BOARD ACTION REPORT – APPEALABLE ITEM

Project Name:	**Atlantic Crossing**
Project Location:	**Between Veterans Park and NE 6th Avenue**
Request:	**Approval of a Class I Site Plan Modification**
Board:	**Site Plan Review and Appearance Board**
Meeting Date:	**August 22, 2018**

ITEM: **Atlantic Crossing (2018-168):** Architectural Elevations Changes associated with revision of building massing and detailing for approved Architectural Elevations for buildings III and VI at the Atlantic Crossing.

ATLANTIC CROSSING

BLDG III ELEVATIONS

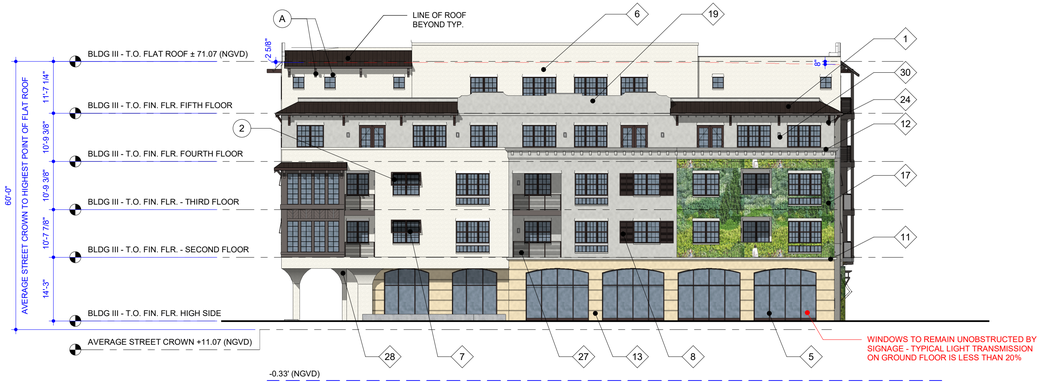
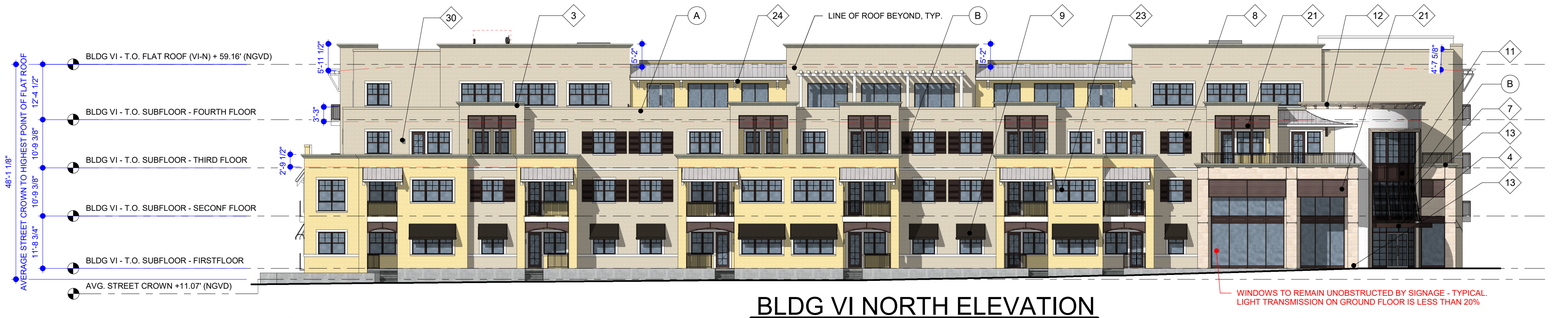
ARCHITECTURAL ELEVATION REVISIONS 7.19.2018
GENERALLY REVISE ELEVATIONS TO BE MORE CONSISTENT WITH ANGLO CARIBBEAN, INCLUDING:
- SCULPTED FORMS AT ARCADE AND AT FEATURE ELEMENTS OF THE BUILDING
- RE-SCALE WINDOWS AT CORNERS
- WOOD DETAILING AS ACCENT AT VERTICAL FORMS
- ENHANCE DETAIL AT BUILDING CAP
- RE-DETAIL ARCADE AND LOW ROOF FORMS

BLDG VI ELEVATIONS

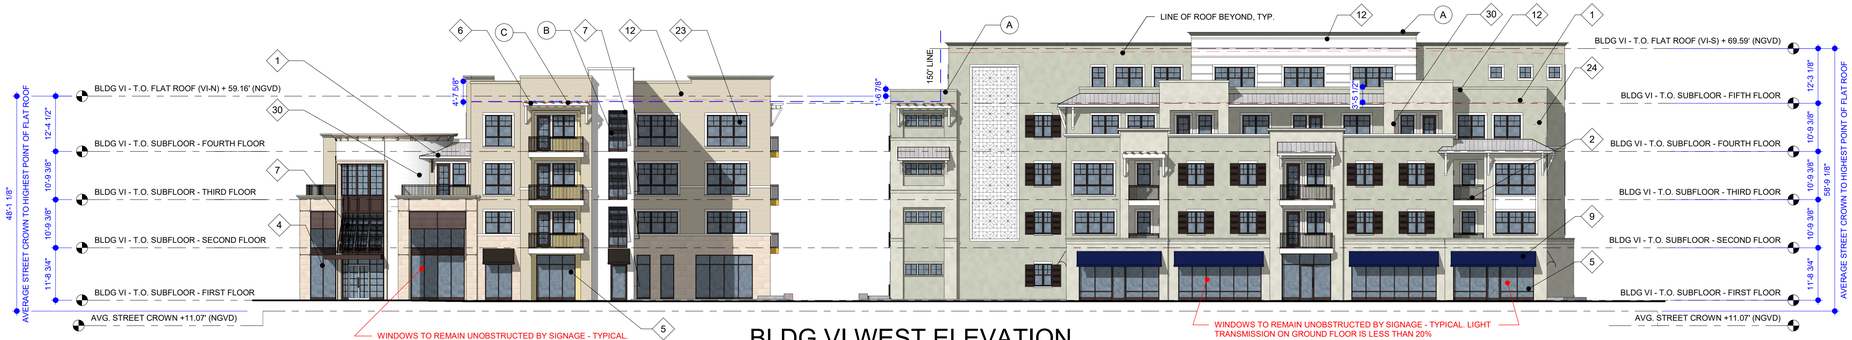
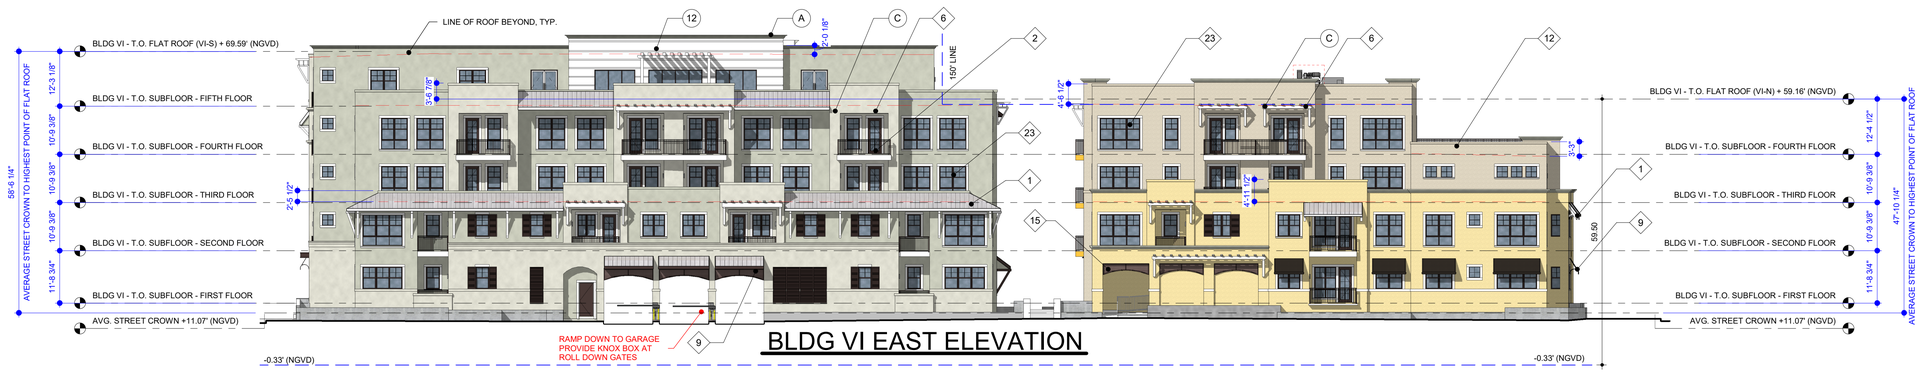
ARCHITECTURAL ELEVATION REVISIONS, 7.19.2018
GENERALLY REVISE ELEVATIONS TO BE MORE CONSISTENT WITH MASONERY MODERN, INCLUDING:
- STRENGTHENING PEDESTRIAN SCALE OF ENTRY TO LEASING (NORTHWEST CORNER)
- ENHANCED HORIZONTAL DETAILING AT BASE - ADDED ROOF FORMS, CONSOLIDATED COLOR, MINIMIZED TALL SLENDER VERTICAL FORMS
- ENHANCE DETAILING AT BUILDING CAP
- ENHANCE DETAILING AT BUILDING CORNERS

BLDG VI COURTYARD ELEVATIONS

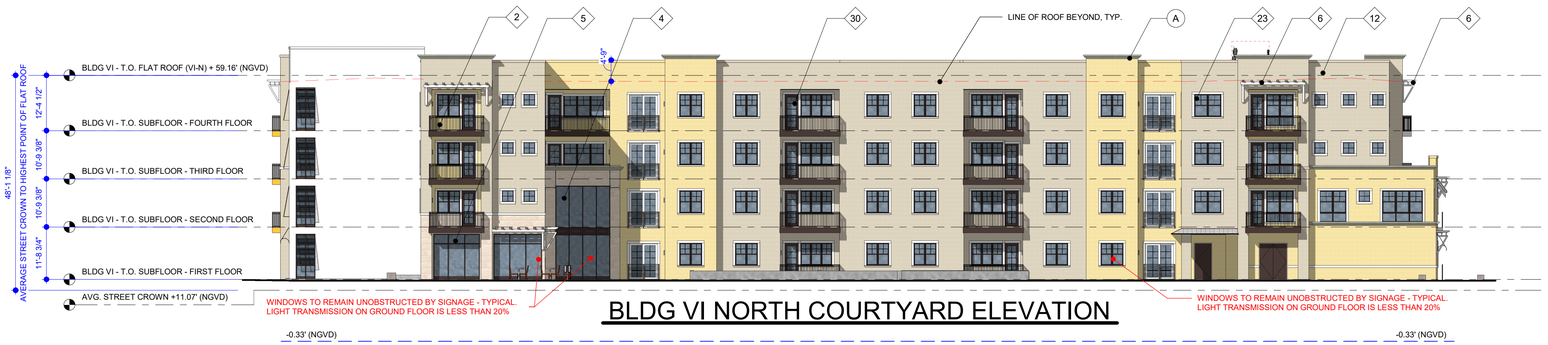
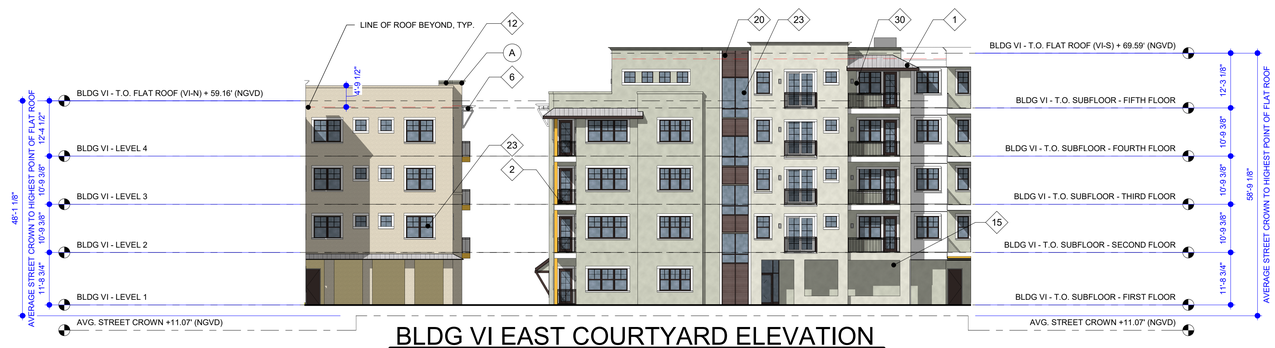
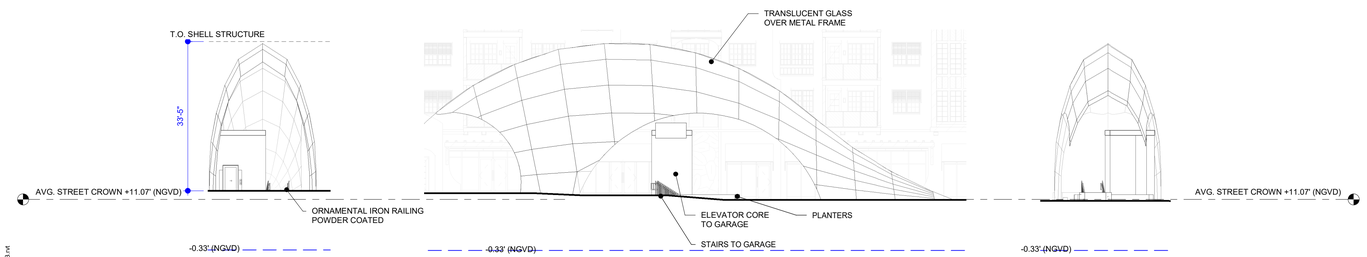
ARCHITECTURAL ELEVATION REVISIONS 7.19.2018
GENERALLY REVISE ELEVATIONS TO BE MORE CONSISTENT WITH MASONERY MODERN, INCLUDING:

- STRENGTHENING PEDESTRIAN SCALE OF ENTRY TO LEASING (NORTHWEST CORNER)
- ENHANCED HORIZONTAL DETAILING AT BASE - ADDED ROOF FORMS, CONSOLIDATED COLOR, MINIMIZED TALL SLENDER VERTICAL FORMS
- ENHANCE DETAILING AT BUILDING CAP
- ENHANCE DETAILING AT BUILDING CORNERS

217093
III WEST ELEVATION
III-4

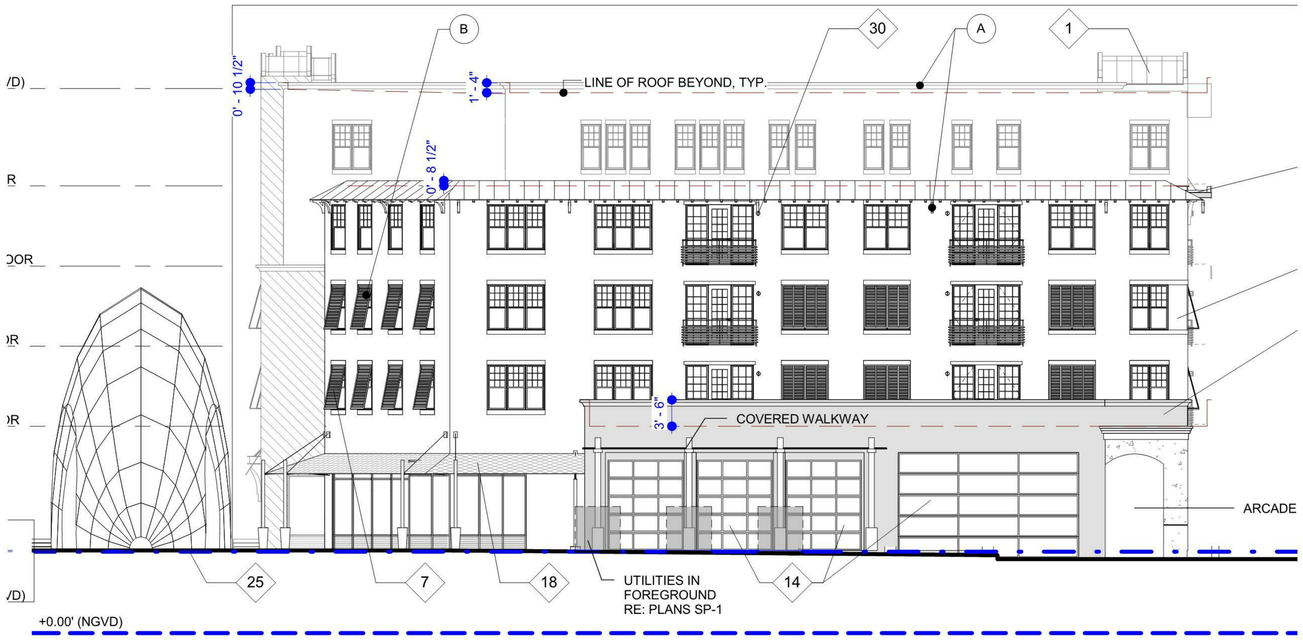
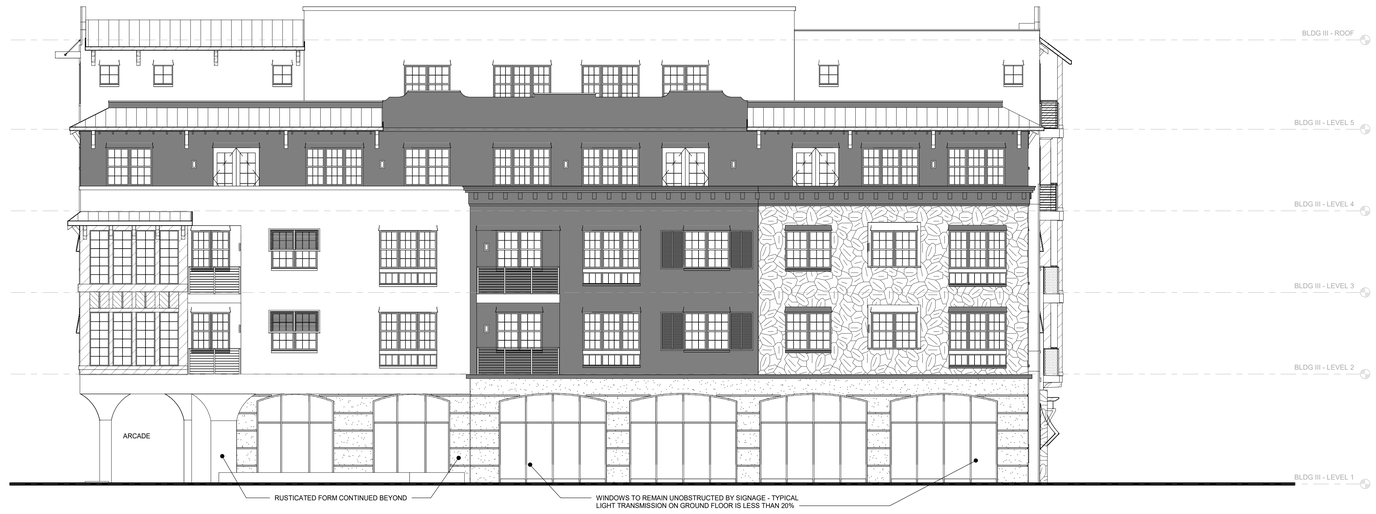
- Building massing is changed from having multiple narrow columns into having fewer solid and wider columns. Building has six narrow columns and now three wider columns are proposed.
- Roofing details are introduced. Previously approved roof was flat roof with parapet.
- Different and more versatile styles of windows are introduced with this proposal.
- More balconies are proposed. Balcony design has also changed.
- Arcade style has changed.
- Additional trellis details.
